**VENTURA UNIFIED SCHOOL DISTRICT
ROOFING REPLACEMENT AT LEMON GROVE ELEMENTARY SCHOOL**

BID # E21-24

ADDENDUM #01

1 ROOF PLAN
A-101A SCALE: N.T.S.

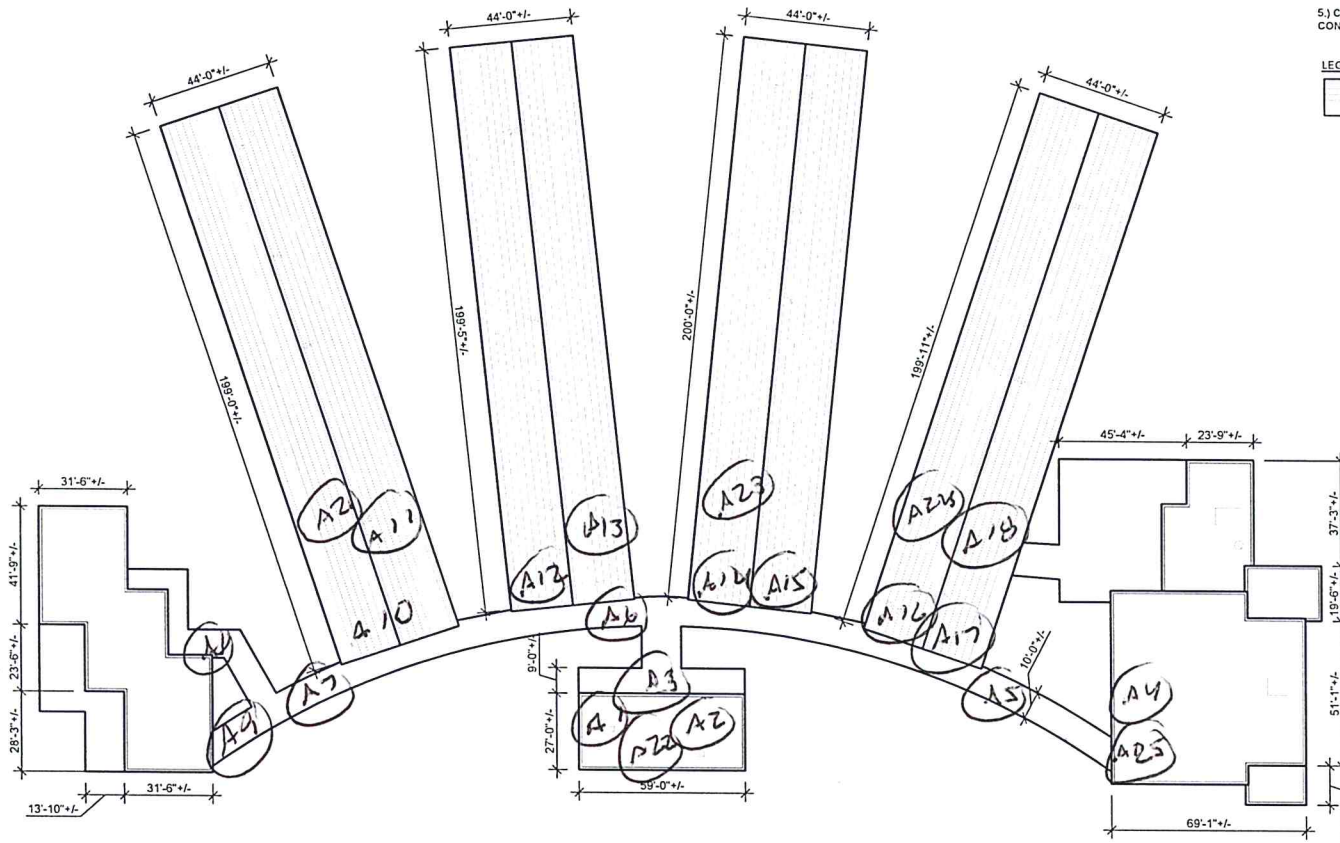
1. Review attached findings regarding the roofing at Lemon Grove Elementary School, confirming penetration mastic and identified shingles contains asbestos (Final report not yet received and will be provided to awarded contractor). Please review attached sample site map for locations where ACM singles occur. Contractor is responsible to provide all required removal and abatement of asbestos-containing material in bid, following all applicable codes, regulations, and safety standards. A certified hazardous-material removal firm will be required for proper reporting, removal and disposal of hazardous material.
2. Prequalification in Quality Bidders is not required for this project.
